Monticello Nuclear Generating Plant
Docket No. 50-263
Renewed Facility Operating License No. DPR-22

Monticello Nuclear Generating Plant: Sixth Six-Month Status Report in Response to June 6, 2013 Commission Order Modifying Licenses with Regard to Reliable Hardened Containment Vents Capable of Operation Under Severe Accident Conditions (Order EA-13-109), Phases 1 and 2 (TAC No. MF4376)

ENCLOSURE 2

**RESPONSES TO OPEN ITEMS
ASSOCIATED WITH NRC ORDER EA-13-109, PHASE 1**

Figure OI 2-1 - HCVS Nitrogen Pneumatic System

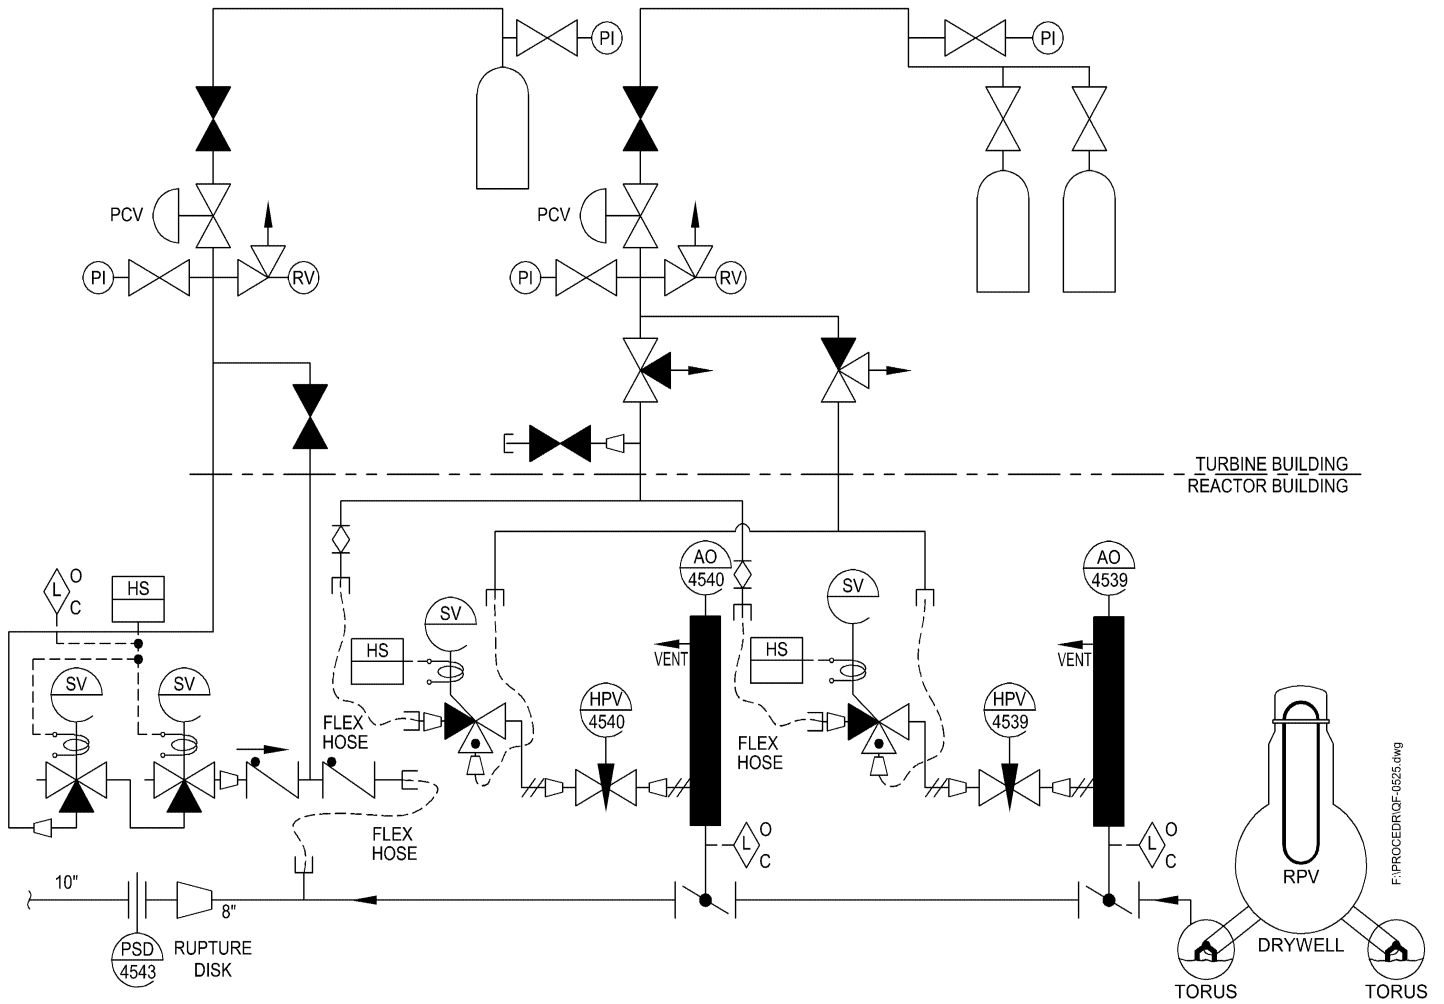
Make available for NRC staff audit documentation of the HCVS nitrogen pneumatic system design including sizing and location.

A calculation has been performed that confirms that the HCVS two (2) nitrogen supply systems that provide pneumatic capacity to the HCVS rupture disc and containment isolation valves are sized adequately. This calculation determined that one (1) nitrogen bottle is required to fully burst the HCVS rupture disc and two (2) nitrogen bottles are required to actuate the primary containment isolation valves over 24 hours.

Two (2) new nitrogen supply systems are installed in the 931' east Turbine Building with a remote manual operating station located south of the nitrogen bottles near the B Alternate Nitrogen supply. Pneumatic tubing was routed through the Turbine Building, Condenser Room, Reactor Core Isolation Cooling (RCIC) Room, and Torus Room to the HCVS rupture disc and containment isolation valves. The primary location for control of the HCVS remains in the third floor Emergency Filtration Train (EFT) Building at the Alternate Shutdown System (ASDS) panel.

The design of the new HCVS nitrogen system is provided in Figure OI 2-1 below.

A check valve is provided on the rupture disc pneumatic supply connection to the HCVS piping to prevent backflow to the remote operating station (see Figure OI 2-1 in Open Item Response 2). With exception of the rupture disc pneumatic supply, the HCVS piping is designed to have no interfaces with other plant systems, and all valves that open external to the system are designed to the system operating conditions. Once the rupture disk is burst the pneumatic supply will be isolated to prevent migration of hydrogen gas into the pneumatic supply system.
